MEMORANDUM

Date: August 10, 2022	
To: Brian Froelich, Senior Planner	Organization: City of Capitola
From: RRM Design Group	Title: Design Review Team
Project Name: Capitola Senior Living	Project Number: 1783-04-CU22
Topic: 3720 Capitola Road Conceptual Review

Conceptual project documents reviewed include T Tile Sheet, A1 Architectural Site Plan, A2 First Floor Plan, A3 Second Floor Plan, A4 Third Floor Plan (Fourth Floor Similar), A5 Exterior Elevations, and A6 3D Views.

Site Plan

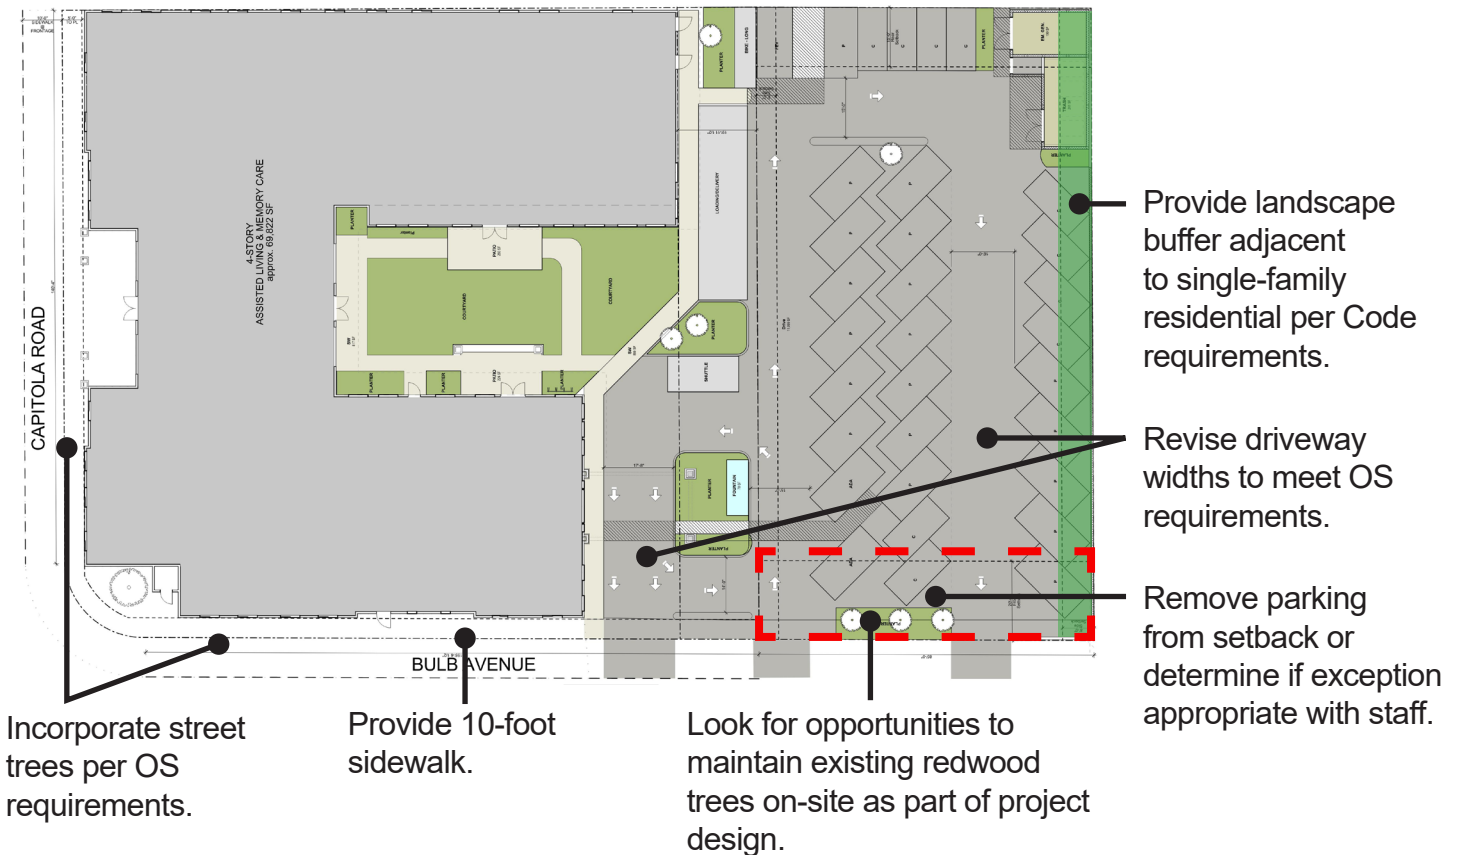
project design. It should be noted that no formal conceptual landscape plan has been included as part of the preliminary project submittal (DRC 17.120.070.M). Going forward, the applicant should provide a conceptual landscape plan to articulate the proposed landscaping for the project in order to allow for adequate staff review. The conceptual landscape plan should also take into consideration the opportunity to maintain existing trees located on-site within the project design, such as the redwood trees located along Bulb Avenue.

To support a pedestrian-friendly streetscape, the OS and DRC dictates that parking facilities be minimized from view from public streets in order to encourage alternative modes of movement (OS 17.82.050.B and DRC 17.120.070.L). As proposed, parking for the project is located at the southern portion of the site and is accessed off of Bulb Avenue. OS 17.82.050.B.1 notes that no parking is allowed within a front or street side setback area. However, as seen on Sheet A1, it appears parking is proposed within the street side setback area. Applicant should clarify with staff if parking within the street side setback is acceptable and if determined to be adequate, should then comply with the design standards noted in OS 17.82.050.B.1.b. Per OS 17.82.050.B.2, the maximum width of a new one-way driveway crossing a public sidewalk is 12 feet and 20-feet for a two-car driveway. One-way driveway widths on the plan are noted at 14-ft, 15-ft, and 16-ft respectively, with two-way driveway widths noted at 17'8". Going forward, applicant should revise driveway designs to ensure consistency with OS 17.82.050.B.2 requirements. Consistent with OS 17.82.050.B.3, the applicant has proposed three curb cuts along Bulb Avenue, two one-way and one two-way. Designated loading area for the project is identified on Sheet A1 at the eastern portion of the parking area, consistent with OS 17.82.050.B.6 requirements.

Capitola Road Concept

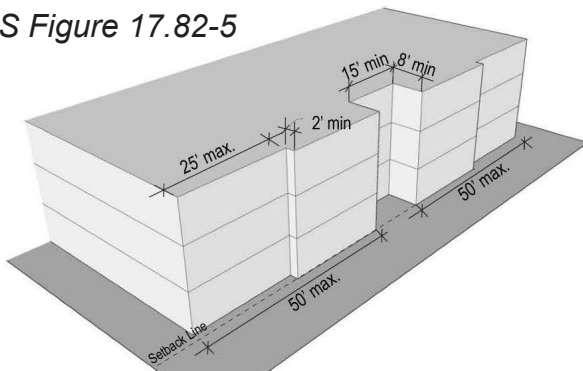
Introduce additional projecting/recessed massing elements from ground level to roof at prominent street facing elevations, to minimize box-like appearance and enhance proportionality.

Vary massing height at ground-level to provide more human-scaled connections with one- and two-story elements.

OS Figure 17.82-6

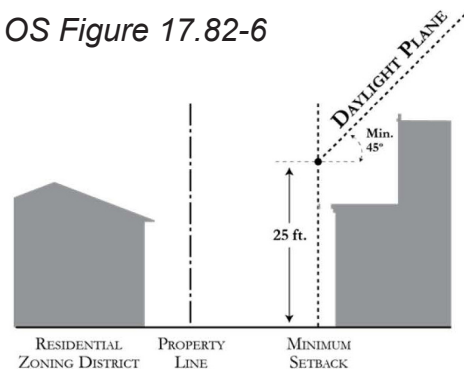
Ensure that the proposed South Elevation meets the requirements of OS 17.82.070.2.

South Elevation

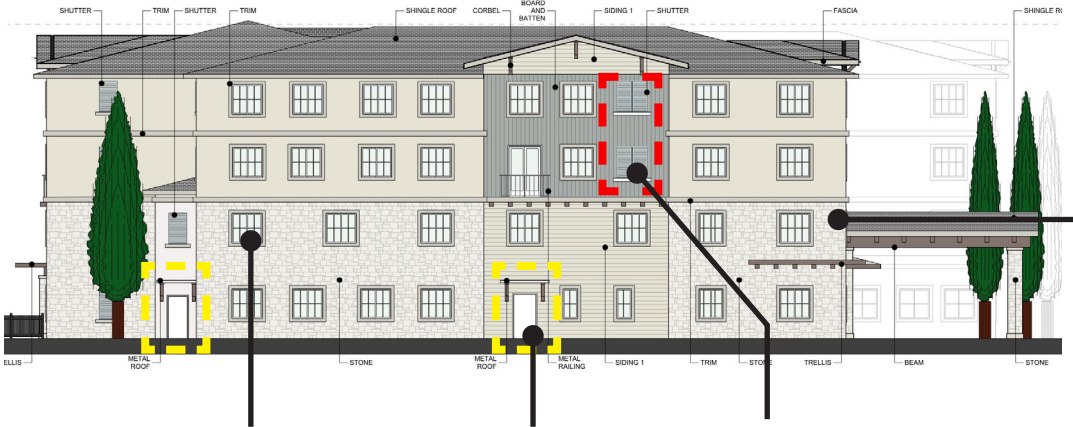
Soften transition of primary entry to box-like building by integrating design interventions to better blend the two design elements. Maintain primary entry emphasis.
